2.0 SAFETY LIMITS AND LIMITING SAFETY SYSTEM SETTINGS

DAVIS-BESSE, UNIT 1

Amendment No. 17, 18, 22
8, 17, 80

Figure 3.1-1 Minimum Boric Acid Tank Available
Volume as Function of Stored Boric
Acid Concentration -- Davis-Besse 1

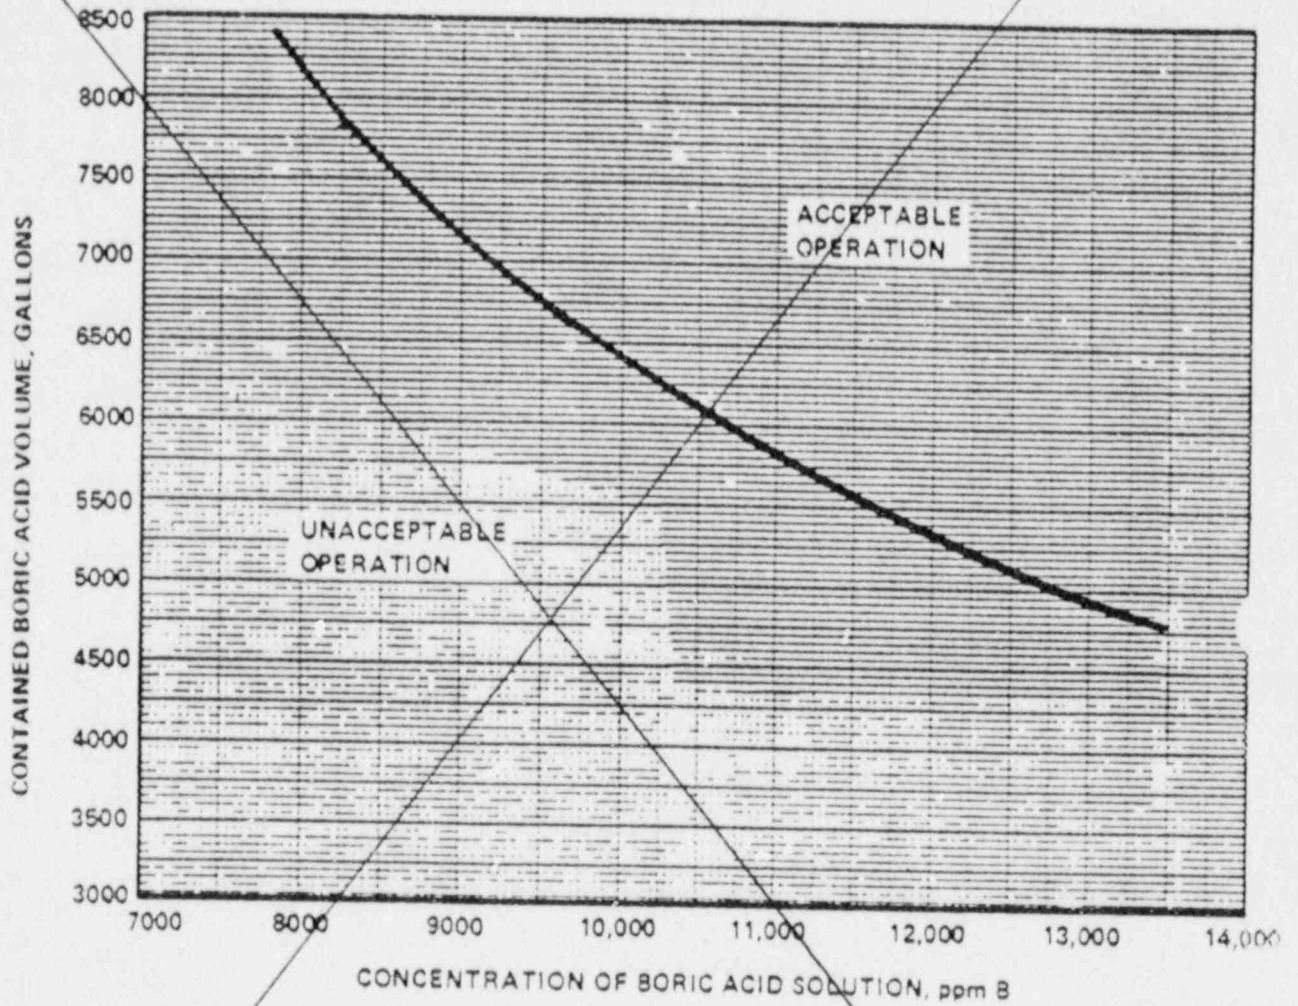
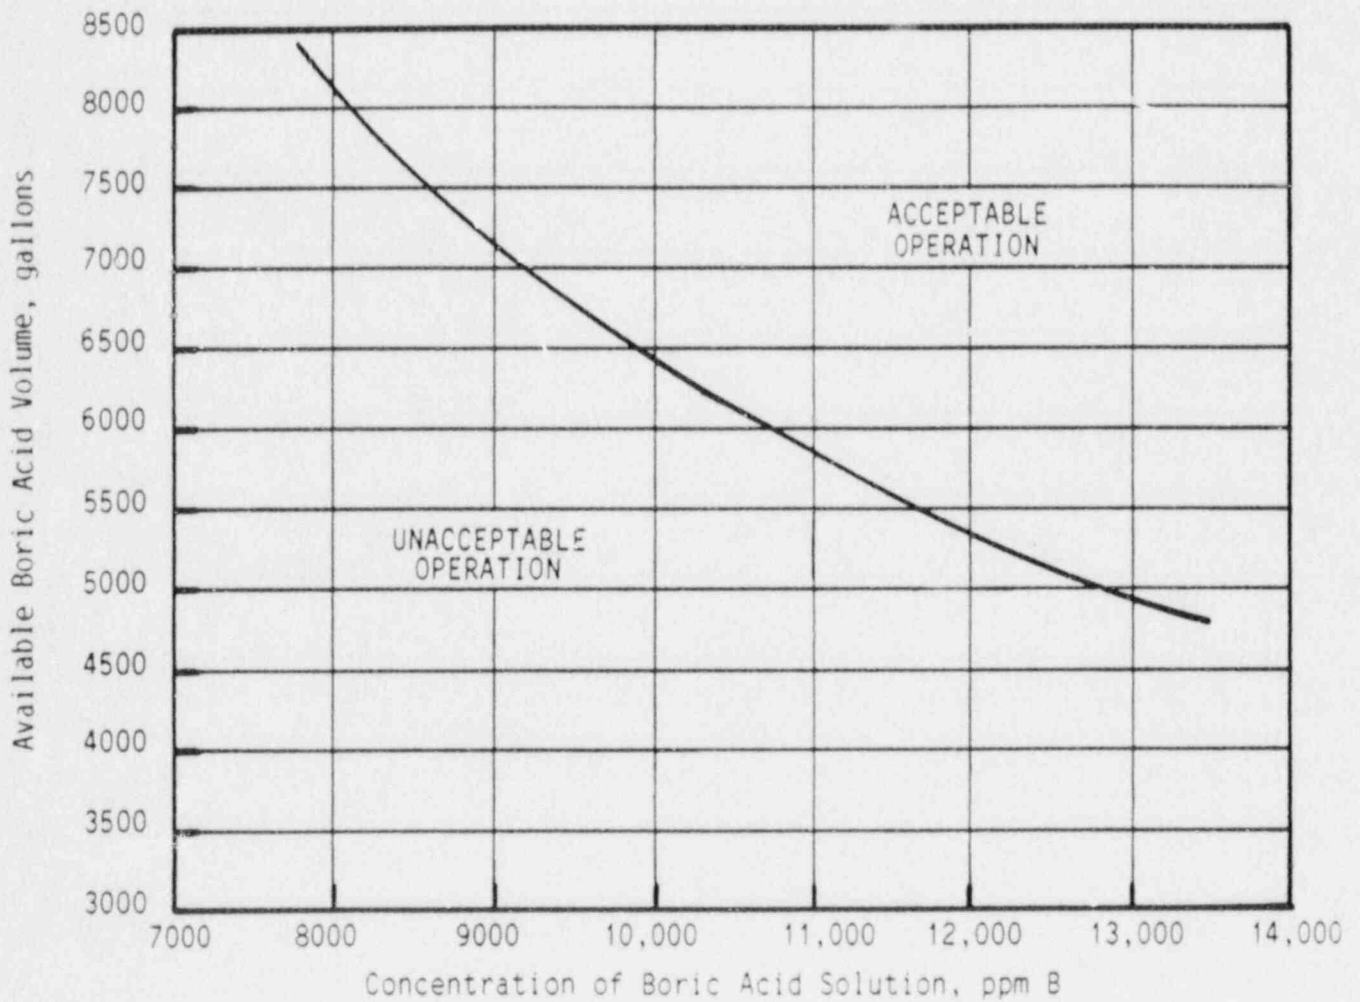
1. A minimum ~~contained~~^{available} borated water volume in accordance with Figure 3.1-1,
2. Between 7875 and 13,125 ppm of boron, and
3. A minimum solution temperature of 105°F.

Superseded with new Figure 3.1-1

Figure 3.1-2a Regulating Group Position Limits,
 0 to 325± 10 EFPD, Four RC Pumps --
 Davis-Besse 1, Cycle 6

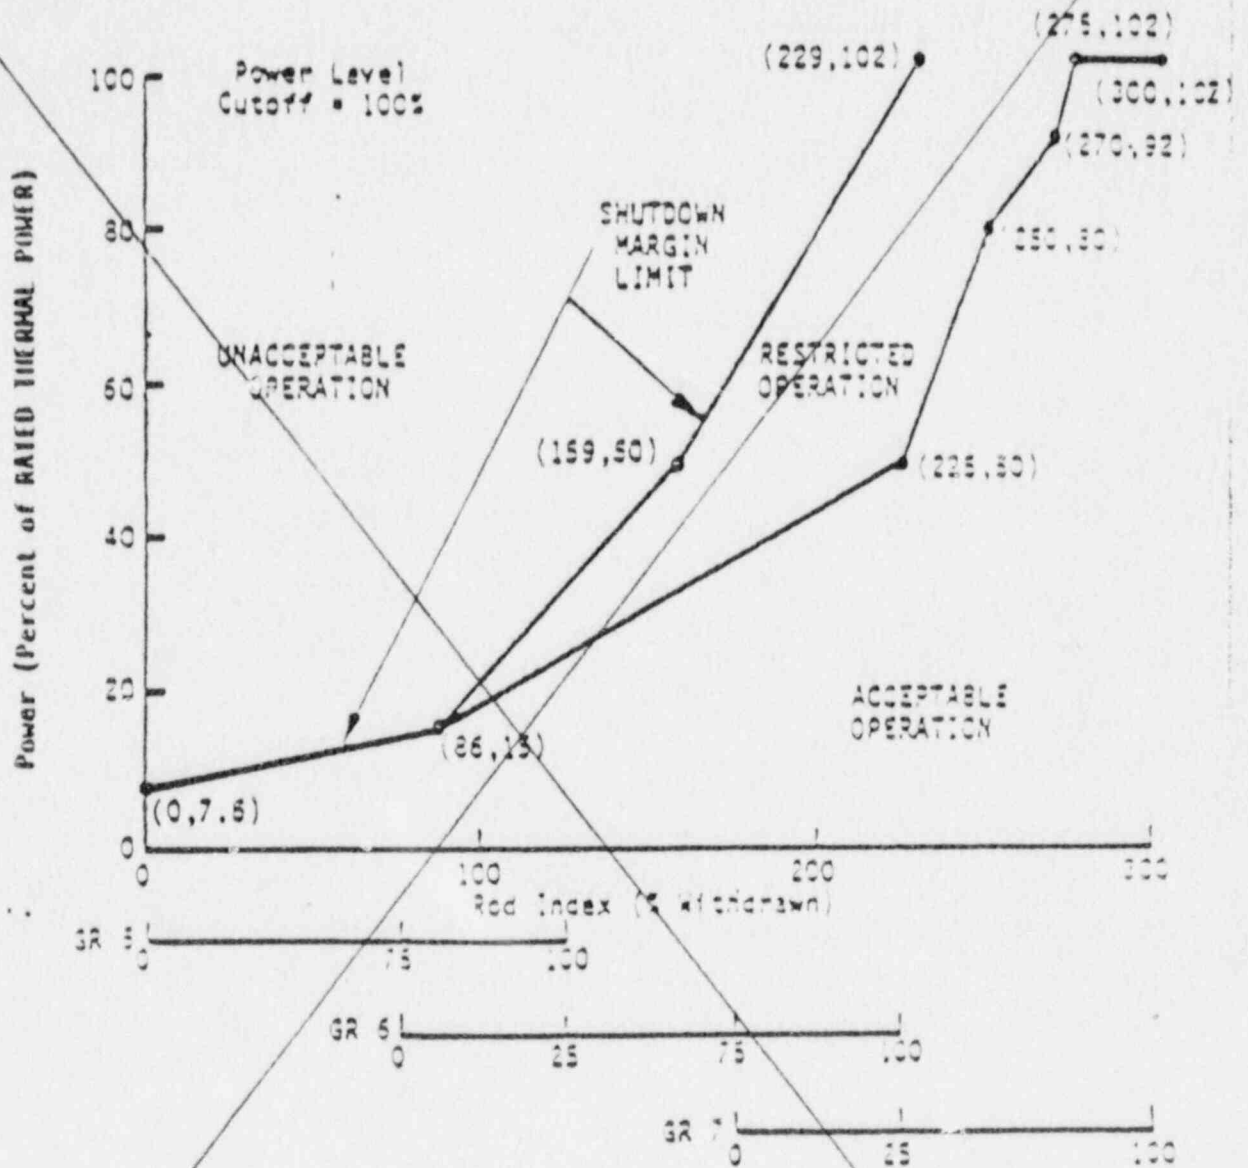
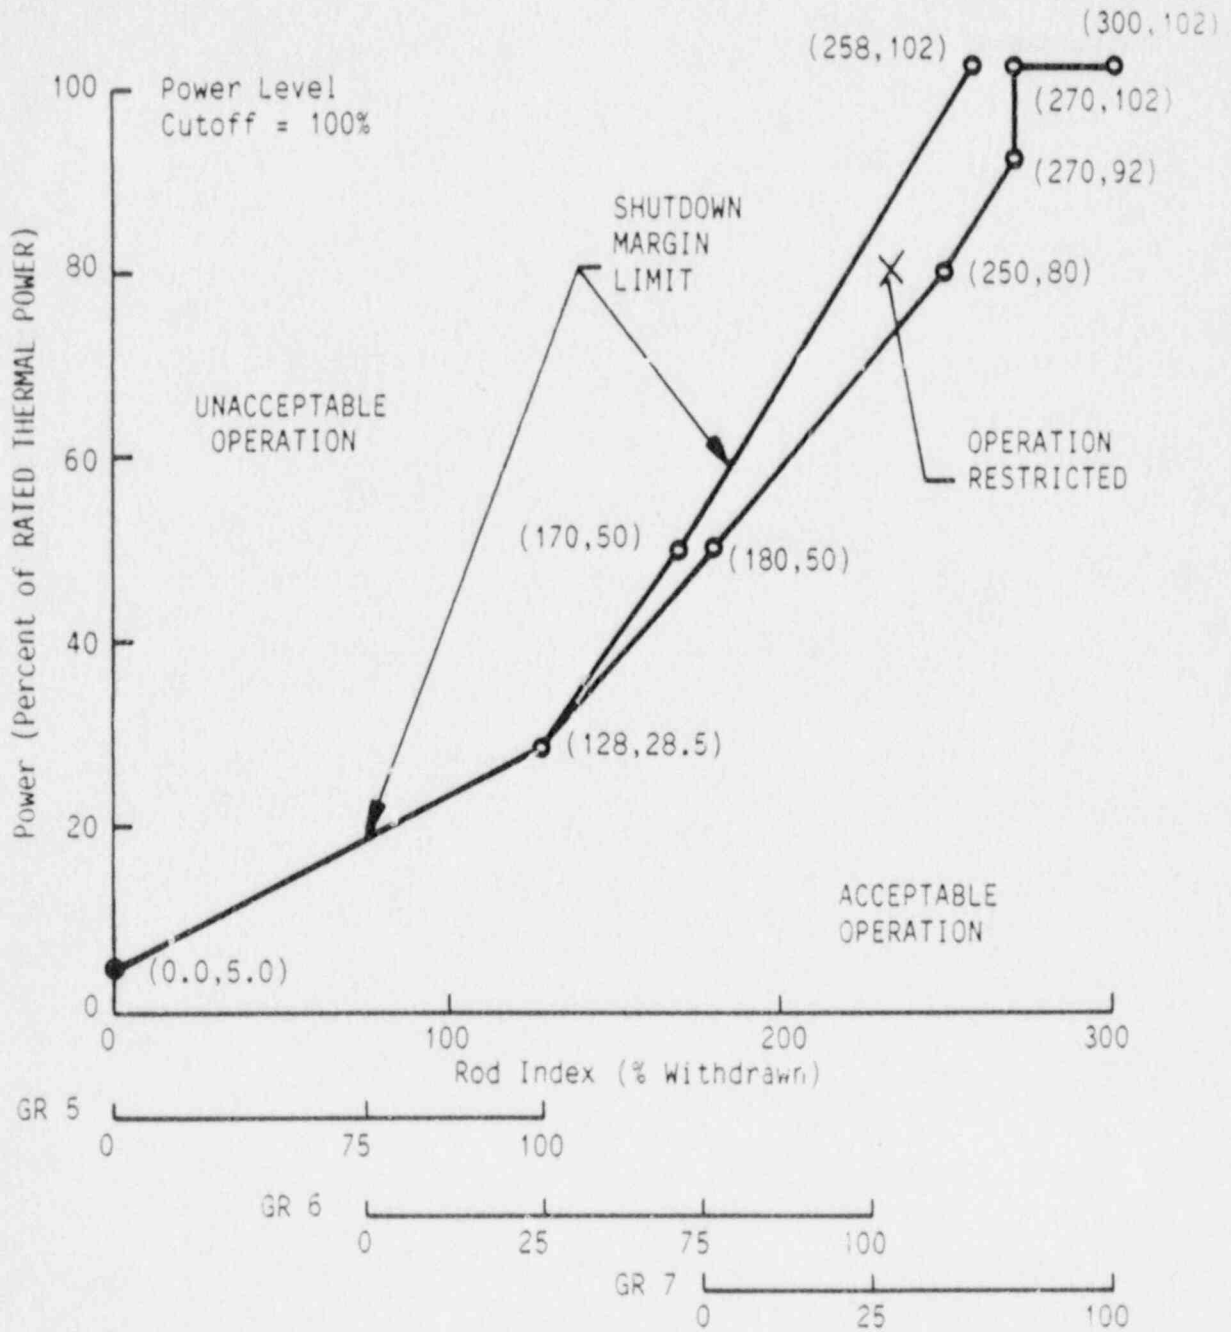
3.1.3.6 The regulating rod groups shall be limited in physical insertion as shown on Figures 3.1-2a, ~~2b, 2c, and 2d~~ and 3.1-3a, ~~3b, 3c and 3d~~. A rod group overlap of $25 \pm 5\%$ shall be maintained between sequential withdrawn groups 5, 6 and 7.

Superseded with new Figure 3.1-2a

Figure 3.1-2b Regulating Group Position Limits After
 325 ± 10 EFPD, Four RC pumps, APSRs
 Withdrawn -- Davis-Besse 1, Cycle 6

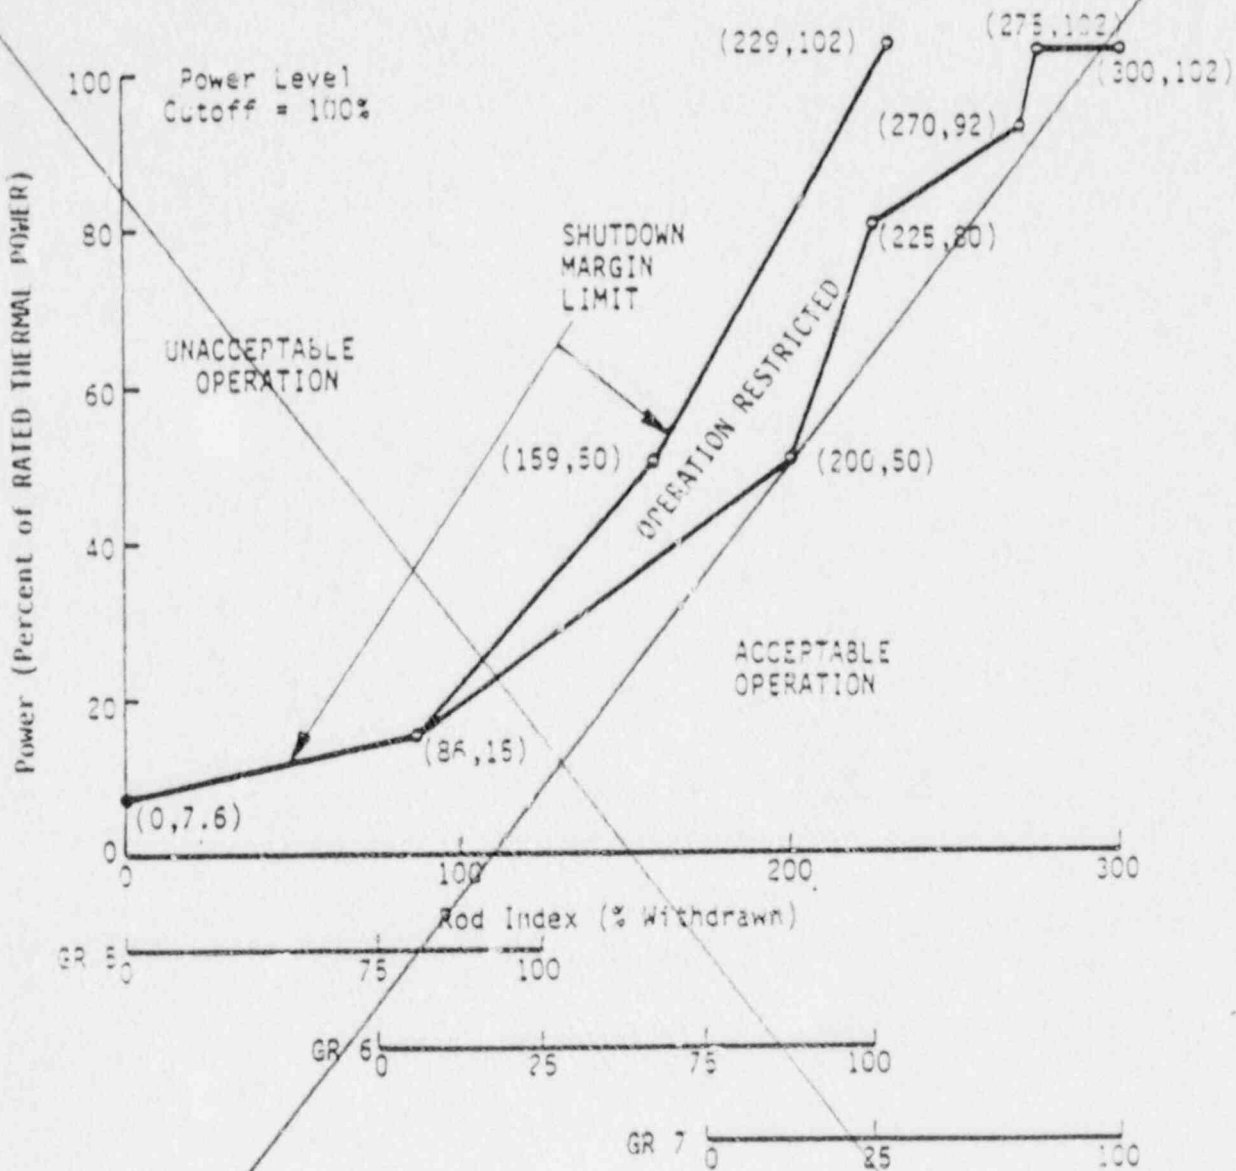
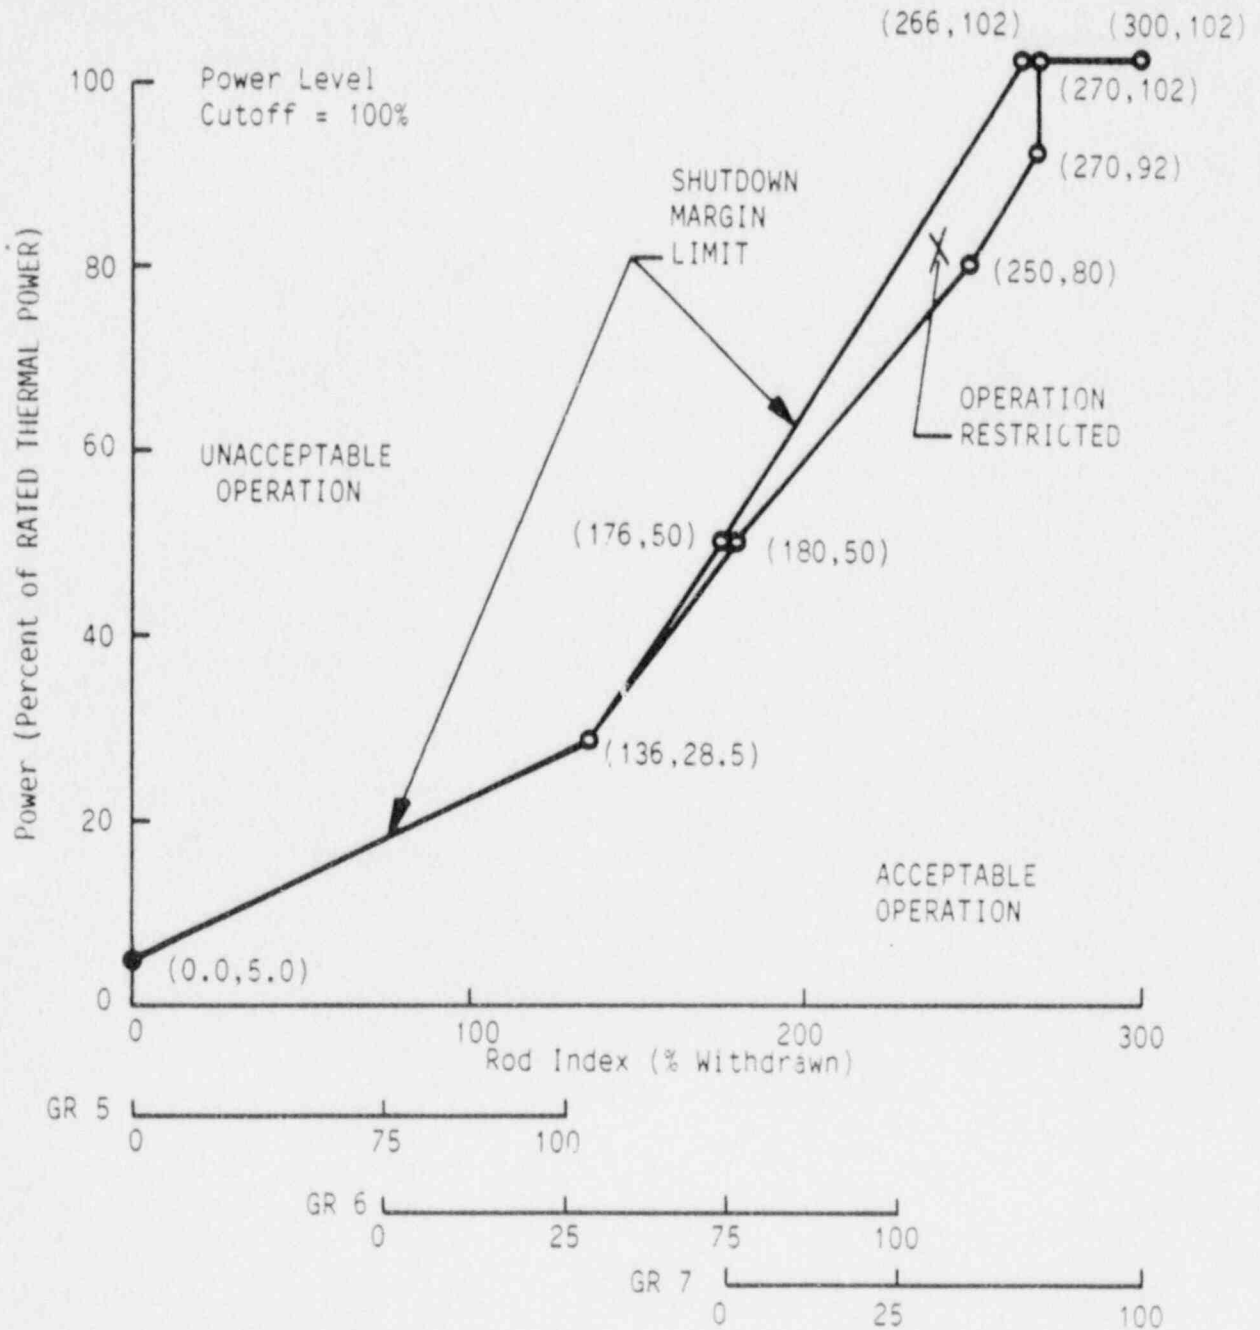
Superseded with new Figure 3.1-2b
